City of Binghamton
Water Street Development Corporation
Special Meeting
Wednesday April 12, 1:00 PM
Mayor's Conference Room, City Hall, 4th floor

RESOLUTION 23-6 A RESOLUTION OF THE CITY OF BINGHAMTON WATER STREET DEVELOPMENT CORPORATION TO ACCEPT A GARAUNTEED MAXIMUM PRICE OF \$22,060,245 FOR THE DEVELOPMENT OF THE PARKING GARAGE AND \$3,050,300 FOR THE SIXTH FLOOR PODIUM BY UNITED - PIKE DEVELOPMENT JV, LLC

City of Binghamton: Water Street Garage

Water St Municipal Parking Garage Contract Document List
4/5/2023

1 PARKING GARAGE FOURTH LEVEL PLAN
30' x 14'

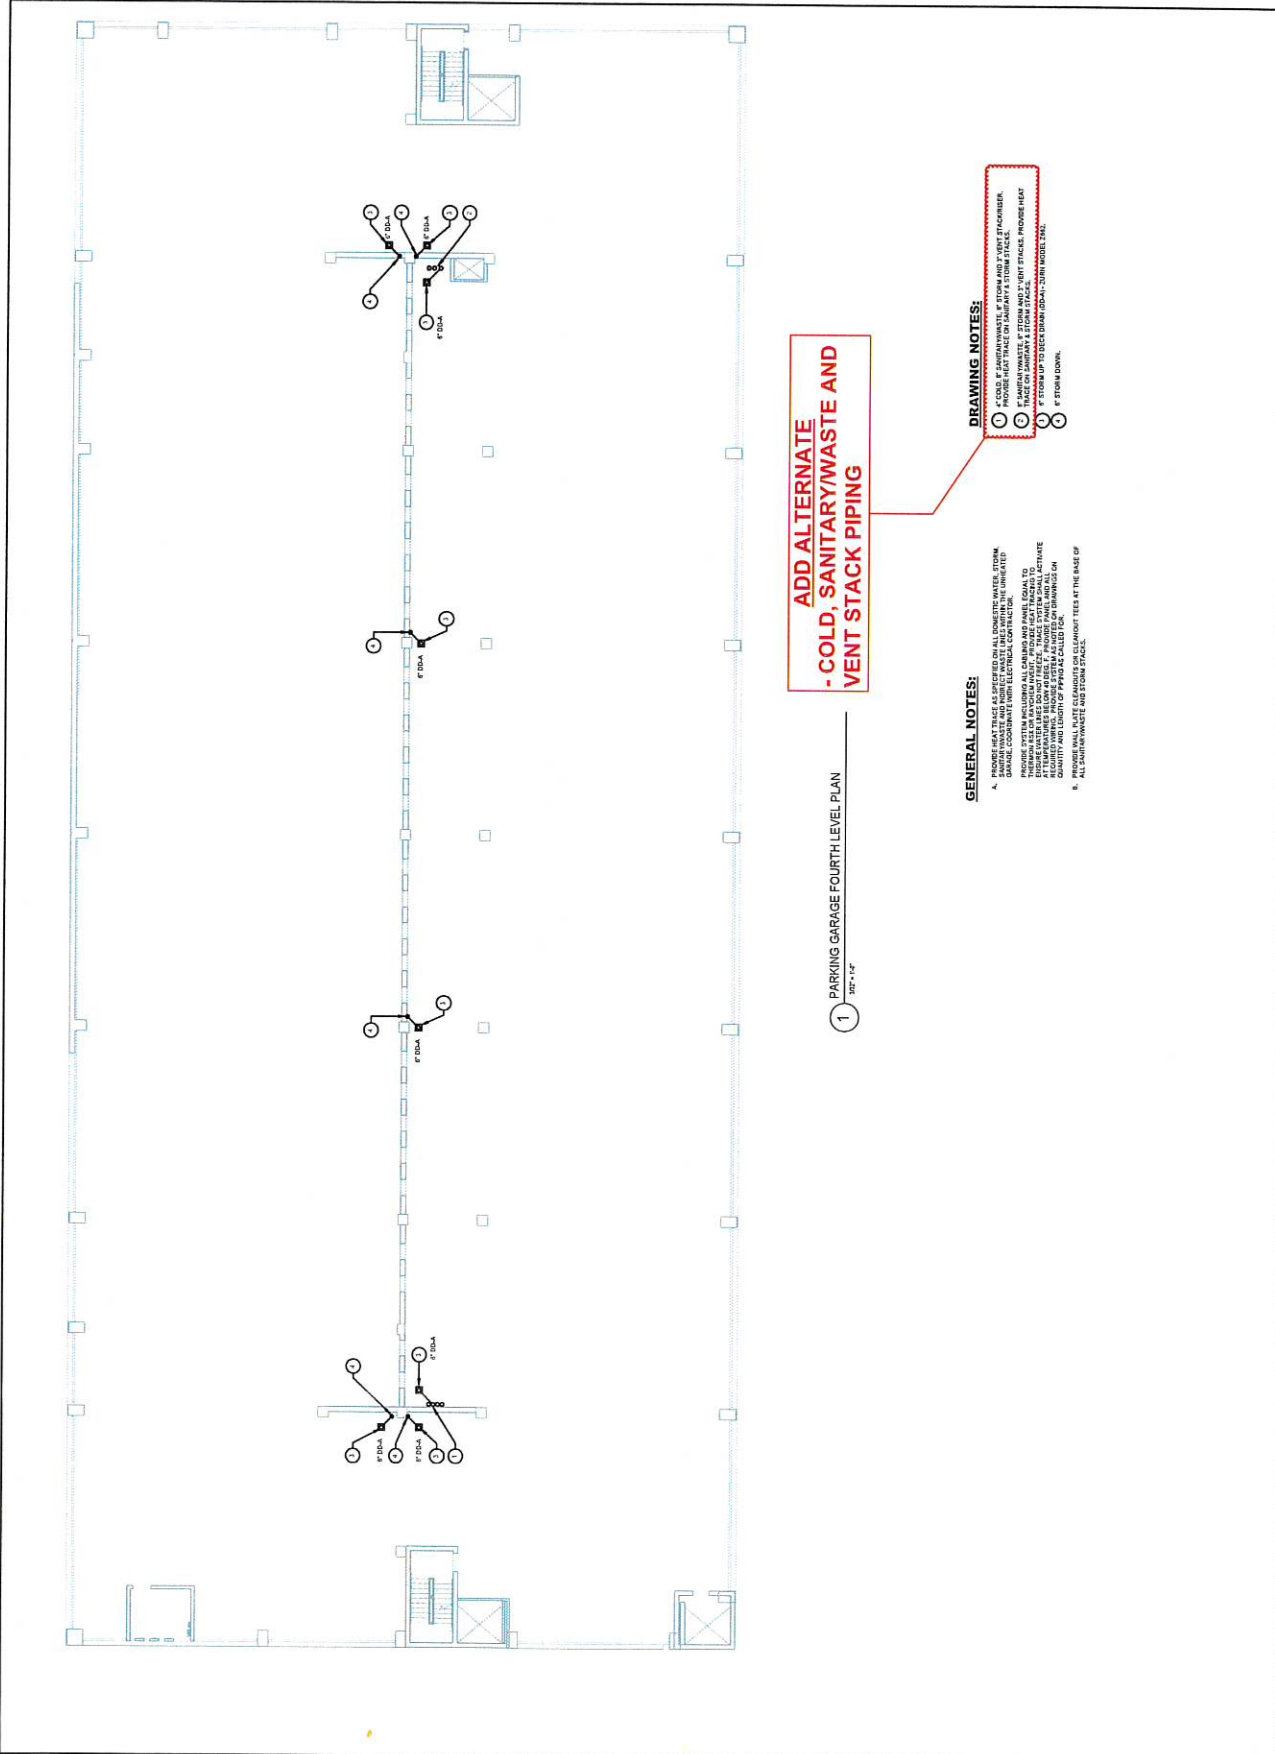
- *Installation of the fire protection service to future apartments on shown on FP301*
 - *Installation of the domestic water, storm and sanitary/waste and vent piping as shown on P111 through P115*

**ADD ALTERNATE
- COLD, SANITARY/WASTE AND
VENT STACK PIPING**

P115

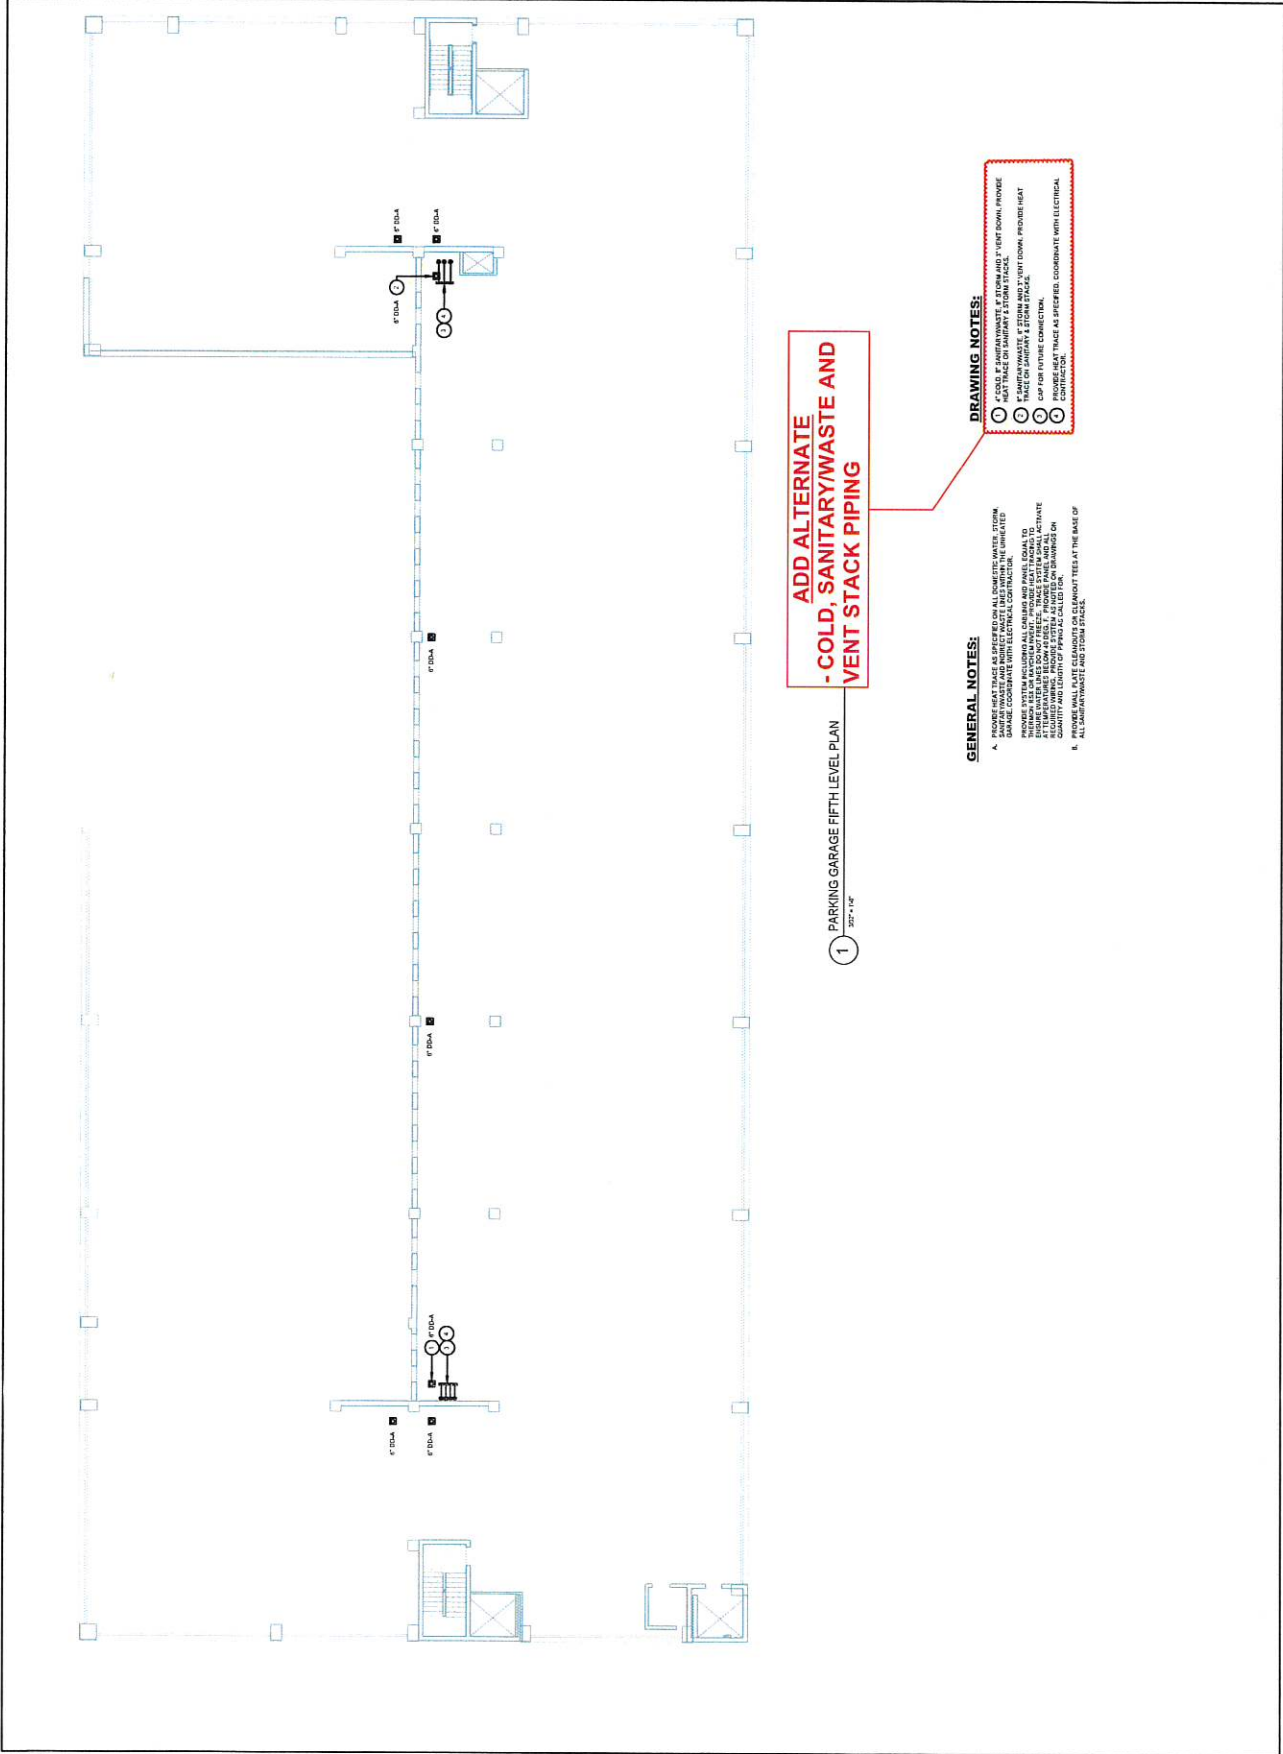
**ADD ALTERNATE
- COLD, SANITARY/WASTE AND
VENT STACK PIPING**
